In Reply Refer To: HSSD/B-174

Name of device: Monroeville 8 inch Composite Offset Block

Monroeville 12 inch MGS Composite Offset Block

Type of device: Blockouts for W-beam barrier systems

Illustration D-2, Monroeville 12" P Block (1 of 1)

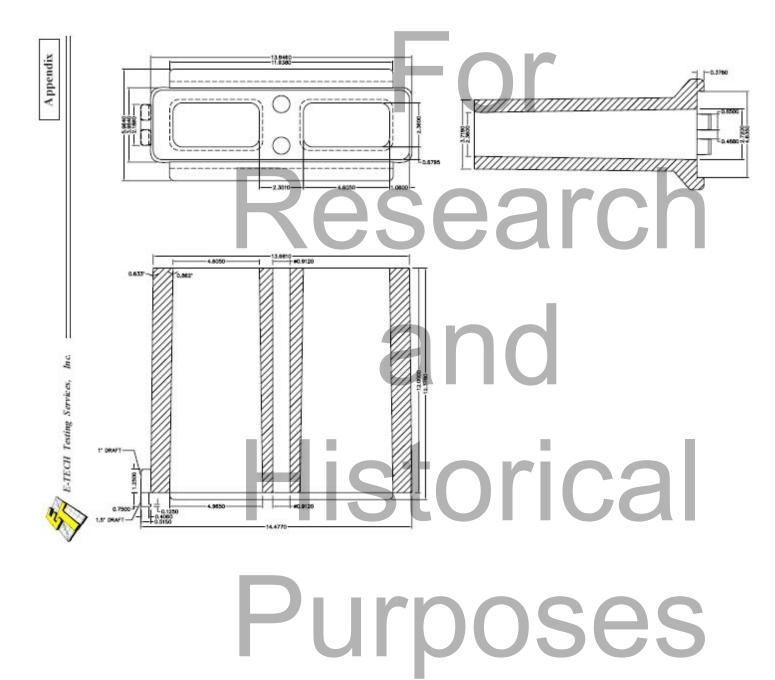
The MGS barrier using the 12-inch Monroeville Offset Blocks described in the above and detailed in the enclosed drawing is acceptable for use on the NHS under the range of conditions tested, when proposed by a State.
